client / project name: PLANZ / WDC MEDIUM DENSITY MODELING

drawing name: BULK AND LOCATION designed by: DAVE COMPTON-MOEN drawn by: DAVE COMPTON-MOEN

A2. SCENARIO A FOR 828M2 SECTION - LACK OF PRIVACY

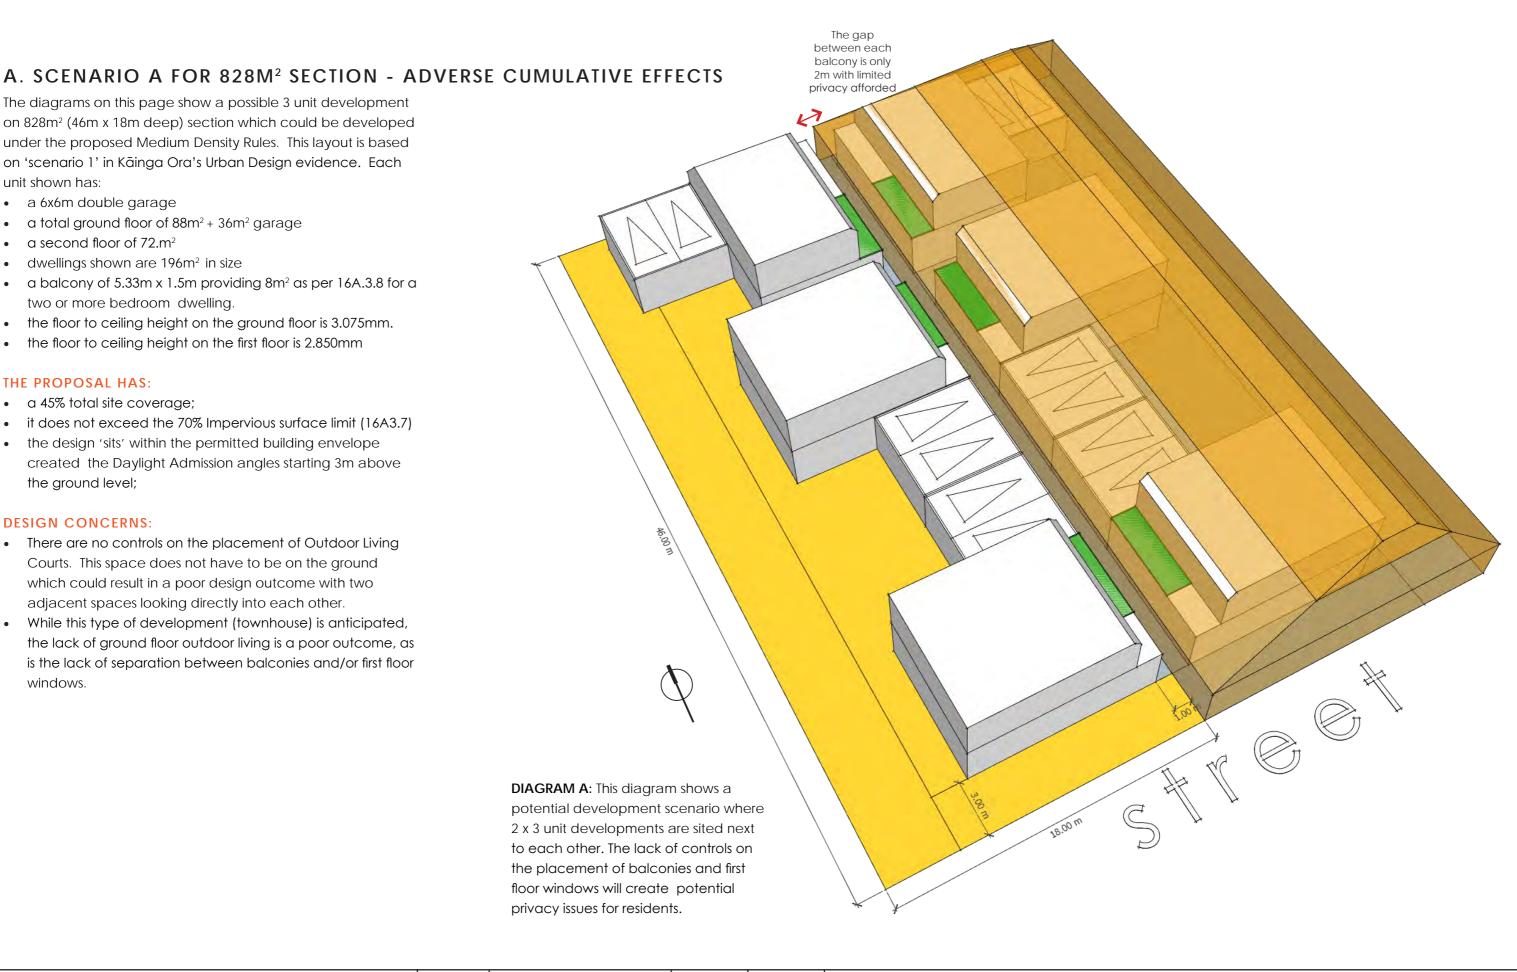
- There are no controls on the placement of Outdoor Living Courts. This space does not have to be on the ground which could result in a poor design outcome with two adjacent spaces looking directly into each other.
- While this type of development (townhouse) is anticipated, the lack of ground floor outdoor living is a poor outcome, as is the lack of separation between balconies and/or first floor windows.

B. SCENARIO B FOR 828M² SECTION - LACK OF DESIGN CONTROLS

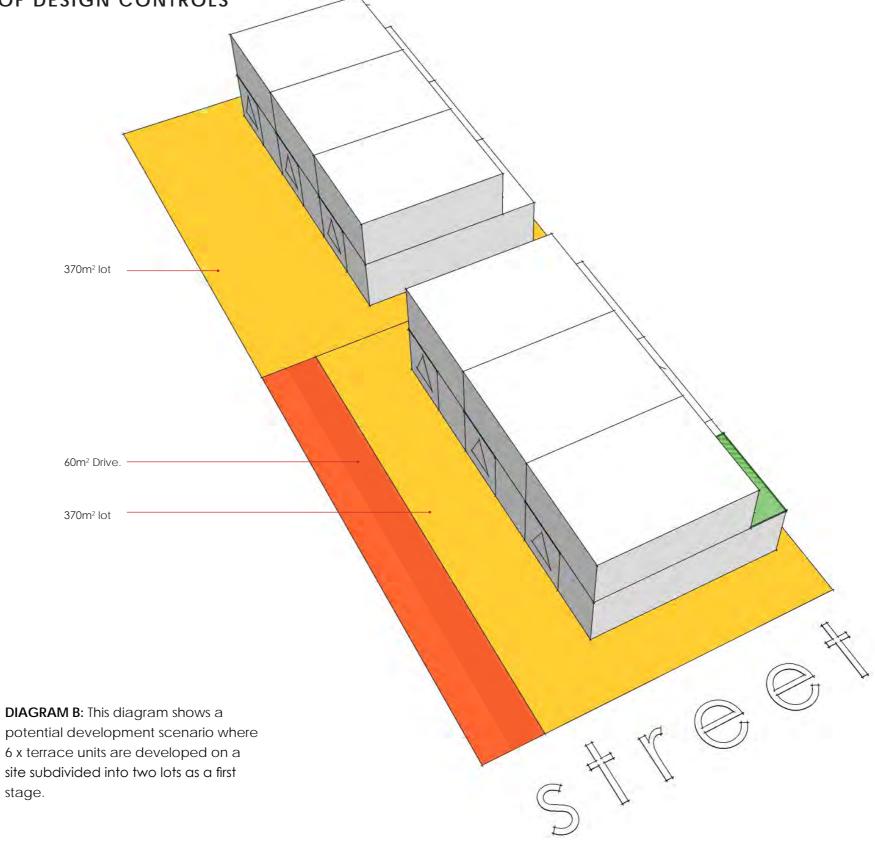
- Following subdivision, the proposal is a permitted activity with no urban design controls required.
- Each unit has limited Outdoor living space while it would be possible to create a dwelling with 3 or more bedrooms.

C. SCENARIO C FOR 828M² SECTION - INSUFFICIENT OUTDOOR LIVING AND INAPPROPRIATE MASSING

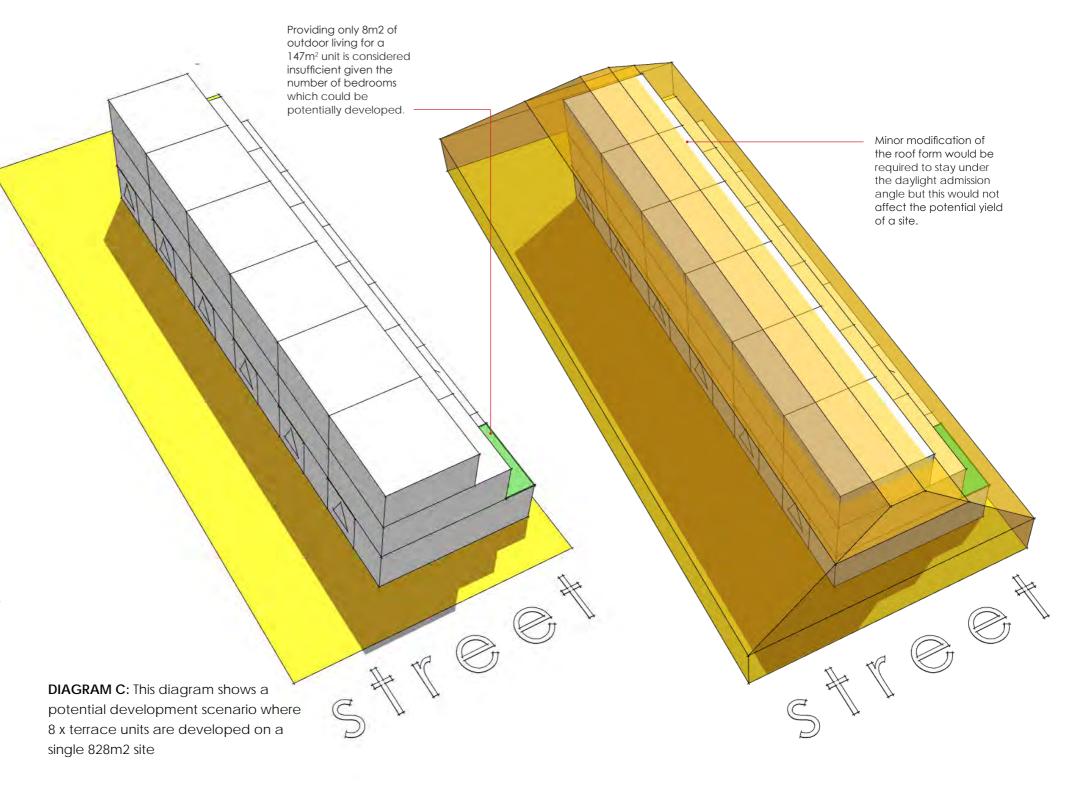
- There are no controls on the placement of Outdoor Living Courts. This space does not have to be on the ground floor which allows for a large terrace house to be developed with a substandard provision of outdoor living provided.
- The controls do not prevent the development of large dwellings on smaller sites with the design to the right considered an over-development of the site
- While this type of development (townhouse) is not necessarily a bad outcome, the lack of ground floor outdoor living is.
- The lack of ground level courtyards leads to excessive building mass located in close proximity to internal boundaries and balcony overlooking issues.

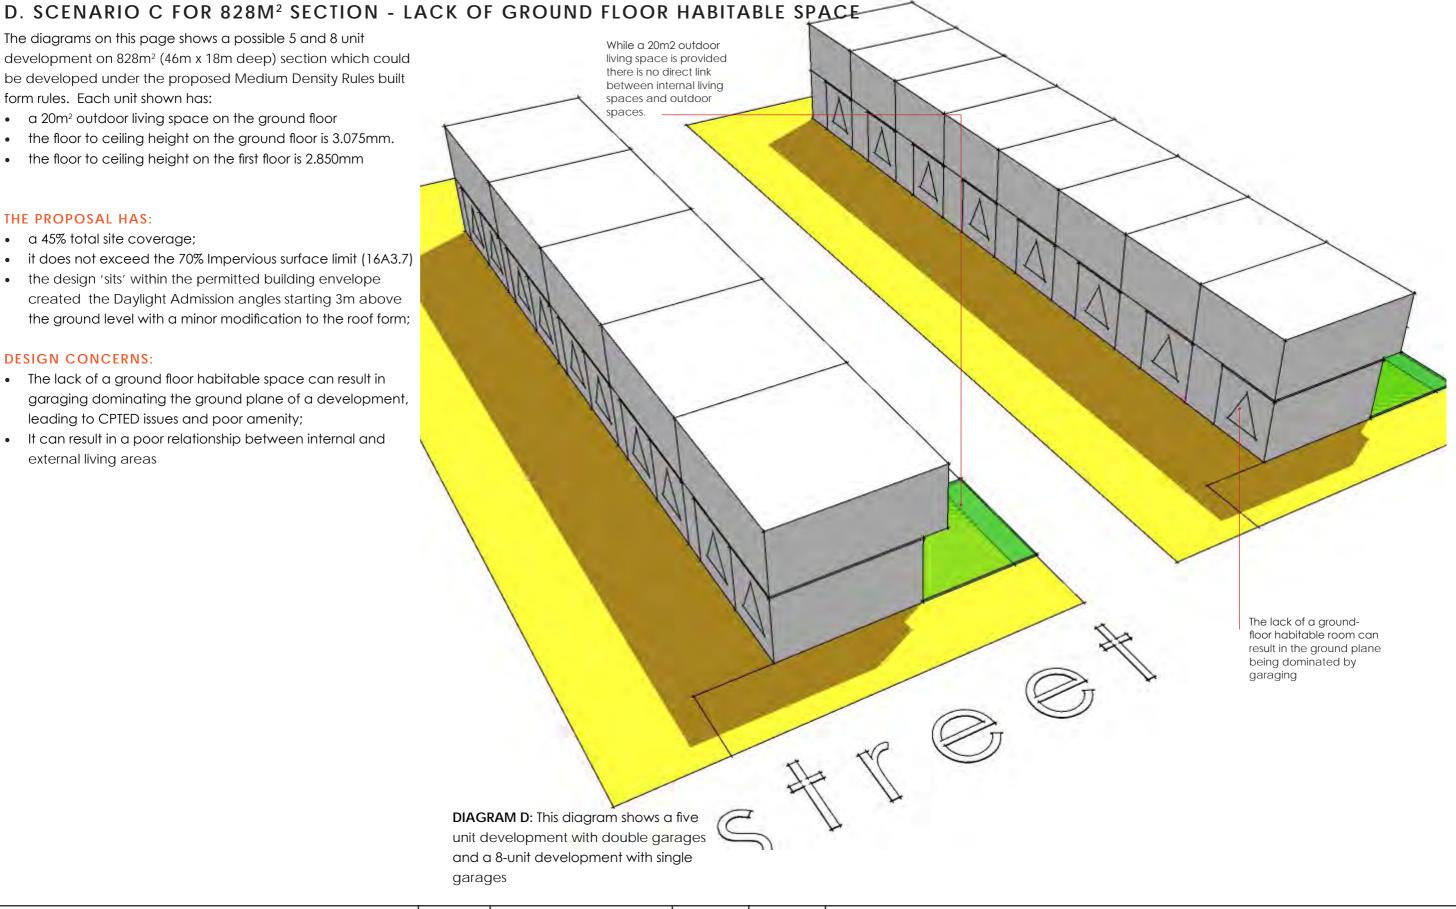
- The lack of a ground floor habitable space can result in garaging dominating the ground plane of a development, leading to CPTED issues and poor amenity;
- It can result in a poor relationship between internal and external living areas

E. RECESSION PLANE CHANGES AND 11M HEIGHT LIMIT

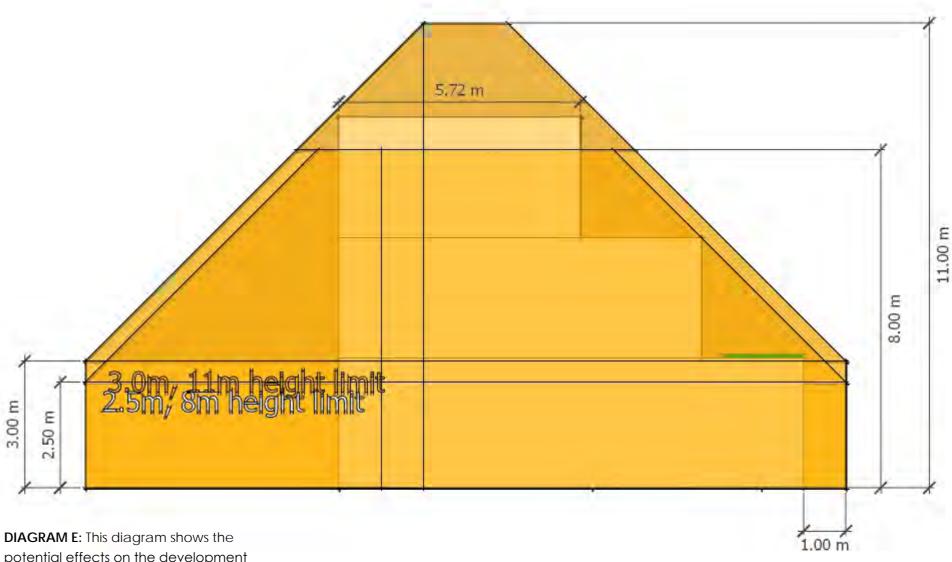
The diagram to the right show a comparison between a 45° recession plane starting at 3m above any internal boundary compared to a 2.5m high starting point which is the starting point in the Lower Density Residential Zone. There is a no noticeable difference between the two options. It is worth noting that the recession planes will have a greater influence on building design on narrower sections, potentially restricting the ability to build up to 3 storeys.

The current diagram shows a 18m wide residential lot allowing for a ~6m wide third floor which is acceptable but if the residential lot were only 14m which is common in older settlements it would not be possible to build a third storey.

The proposed 3.0m starting point for recession planes combined with a 11m height limit is considered an appropriate building envelope for Medium Density developments without creating visual dominance issues on adjoining properties.
